General Manager
Camden Council
70 Central Avenue
Oran Park 2570
Email: mail@camden.nsw.gov.au
13 December 2021

Re: DA 2021/1762/1
First floor addition to existing dwelling
20 Hill Street CAMDEN

Source: 4.6 Variation Request Figure 1 Architectural Plans, Adobe Drafting

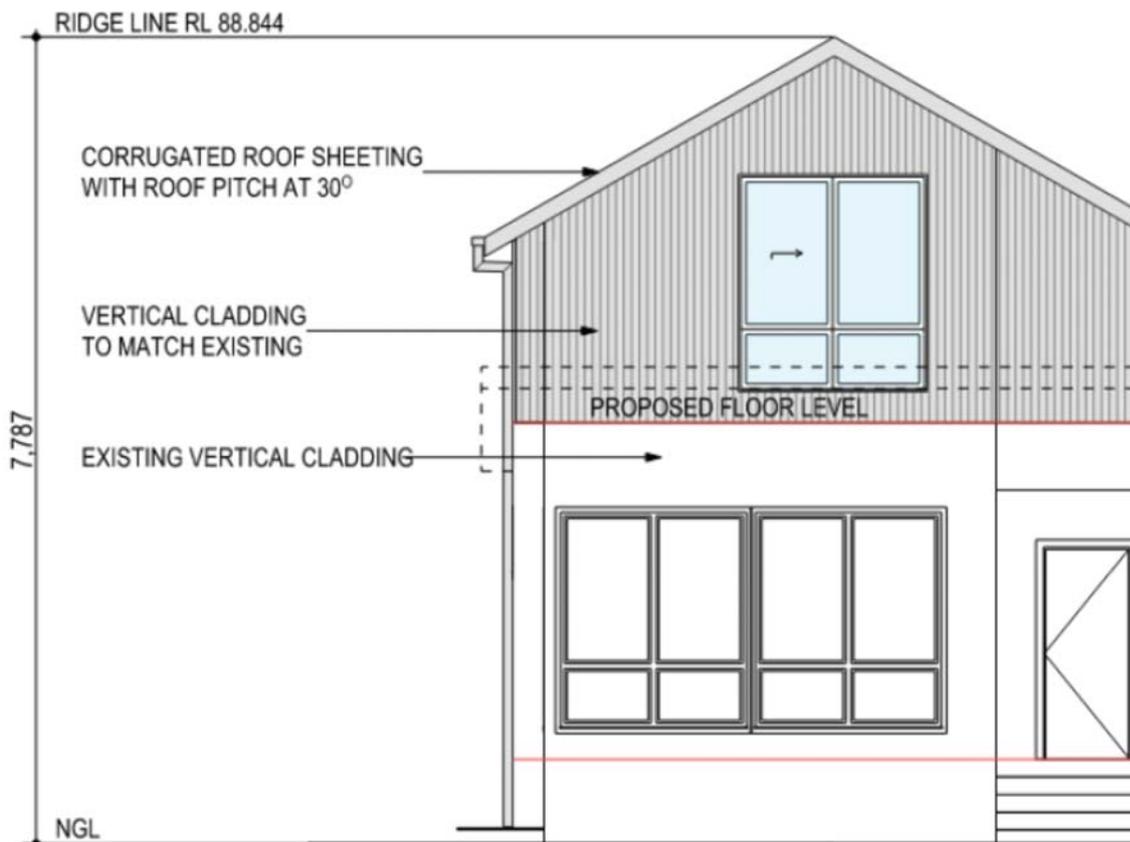
The height limit in the HCA is 7m. The SEE (3.1) states that due to its pitched roof construction, the addition will have a maximum building height at its ridge line of 7.787m. The Architectural Plans shows the height above the site point adopted for establishing levels at RL 88.844.

An RL of 88.844 suggests that the visual impact of the construction from particular perspectives will be significantly greater than claimed.

We question why the simple need for storage space should result in such an inappropriate height exceedance.

Source: *Architectural Plans, Adobe Drafting*

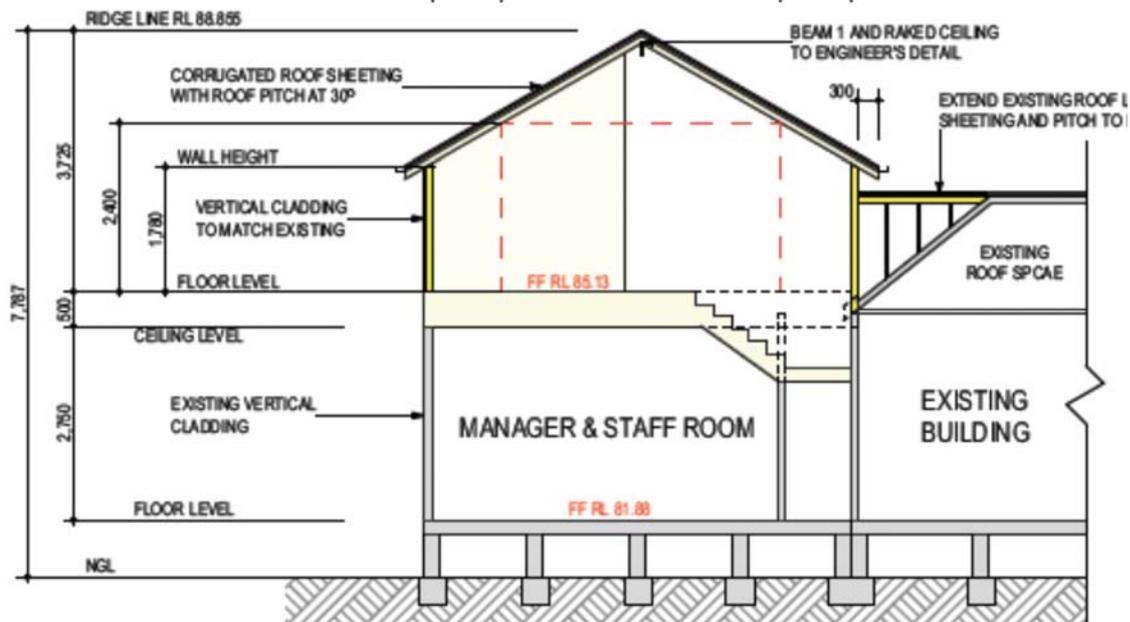
As evident in the drawing below, the height, bulk and scale of the addition in relation to the original cottage is excessive and is not compatible.

As shown in the drawing referenced above the roofline oddly towers above the original cottage.

The gabled roof shape also oddly sits in relation to the lower hipped roof of the cottage. There is every aesthetic reason to minimise the imposition of the roof and certainly no reason to exceed the height limit.

We see no compelling or special reason why the height limit needs to be exceeded and submit that the 4.6 variation request should be denied.
